SMARTELEC

ENERGY SAVING CONTROL

Software Change Notification

Fig.1. location of serial number

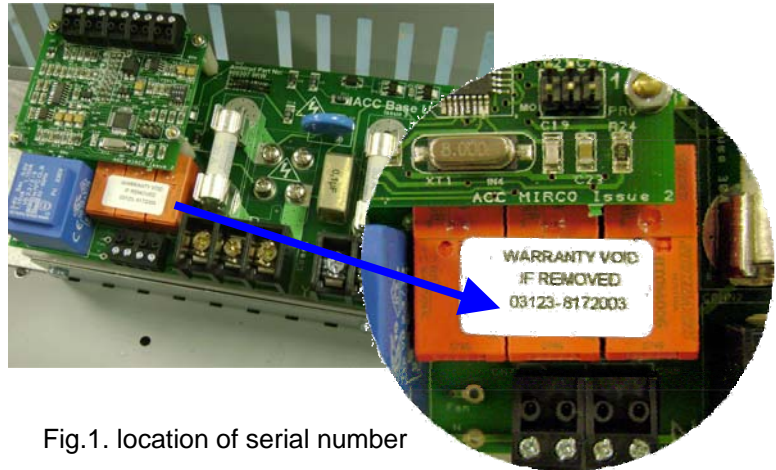
The updated software issue can be identified by the serial number located on a white label attached to three orange relays on the main pcb board (see fig.1). Dismissing the first set of numbers prior to the dash (-), the updated software is on units with serial numbers **greater than 8051001**.

If this symptom appears, firstly check the serial numbers of ALL base units within the network.

If one or more of the units have a serial number **less than 8051001**, call our dedicated service department on the telephone number shown below for further advice and action to remedy the situation.
